# UNITED STATES PATENT AND TRADEMARK OFFICE

# Office Action Summary

10/603,705

**FIG.42**

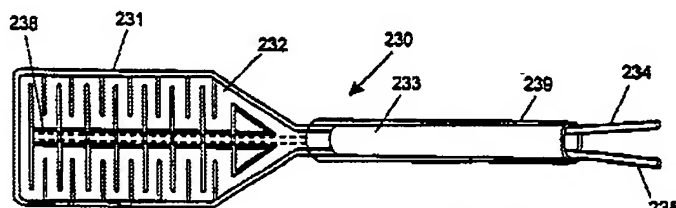
Claims 1-4, 7-17 and 35-36 are rejected under 35 U.S.C. 102(b) as being anticipated by U.S. Patent 5,799,661 to Boyd et al. Boyd et al. teach devices and methods for cardiac surgery including a device for cooling tissue comprising an elongate shaft (Fig. 42, # 233) with a deployable cooling structure at its distal end (Fig. 42, # 231), delivered to the treatment site via a sheath (Fig. 42, # 239). The flexible heat exchanger (231) is collapsible to a pre-deployed

position which can easily fit through an access port into the chest of the patient. The flexible heat exchanger is attached to the distal end of an elongated tubular

shaft (233). An inflow lumen (234) extends through the tubular shaft and is fluidly connected to the flexible heat exchanger. A return lumen (235) extends through the tubular shaft parallel to the inflow lumen. The lumens may be formed integrally with the tubular shaft. The proximal ends of the inflow lumen and the return lumen are adapted for attachment to a circulating pump and a reservoir of cooling fluid (Col. 21, lines 5-25). The flexible heat exchanger is interpreted as a patch and the shaft is longitudinally movable with the sheath. The flexible heat exchanger is made from two sheets of flexible plastic which are heat sealed or RF sealed together to form a serpentine cooling path (232) through the heat exchanger. Preferred materials for manufacturing the flexible heat exchanger 231 include polyurethane, vinyl, polypropylene,

nylon, etc. The flexible heat exchanger may have a flexible backbone (frame) which extends from the distal end of the tubular shaft to the distal edge of the heat exchanger. The flexible backbone may be made from a flexible polymer, elastomer, or a resilient metal wire, such as spring temper stainless steel or a superelastic nickel/titanium alloy, or a composite of metal and plastic. The flexible heat exchanger is rolled, folded or twisted and placed in an introducer sheath 239 in the pre-deployed position (Col. 21, lines 25-41).
